NUMBER: 08-006-23

6.7L Cummins No Start

This bulletin involves replacing the starter nut with the more conductive nut.

Fig. 1
B+ Cable And Starter Stud

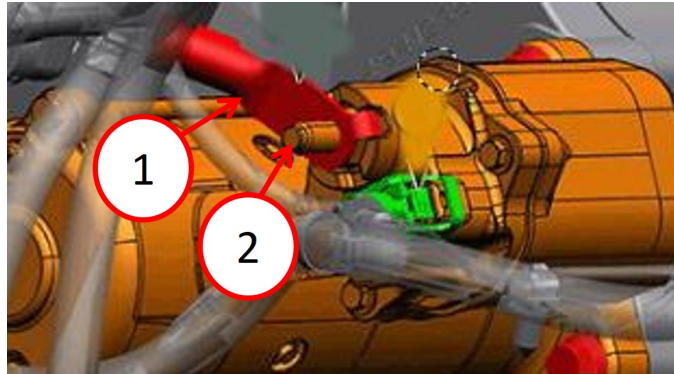
1. Disconnect and isolate both the negative and positive battery cable(s). Refer to the detailed service procedures available in DealerCONNECT/Service Library under: Service Info>08 - Electrical / 8F - Engine Systems / Battery System / Standard Procedure.
2. Raise and support vehicle. Refer to the detailed service procedures available in DealerCONNECT/Service Library under: Service Info>04 - Vehicle Quick Reference / Hoisting / Standard Procedure.
3. Remove the B+ cable nut and the B+ cable from the starter stud (Fig. 1) . **Discard the nut.**

4. Using the new B+ cable nut, install the B+ cable on the starter stud (Fig. 1) . Tighten the B+ cable nut to 18 N·m (13 ft. lbs.).
5. Lower the vehicle.
6. Connect the positive and negative battery cable(s). Refer to the detailed service procedures available in DealerCONNECT/Service Library under: Service Info>08 - Electrical / 8F - Engine Systems / Battery System / Standard Procedure.
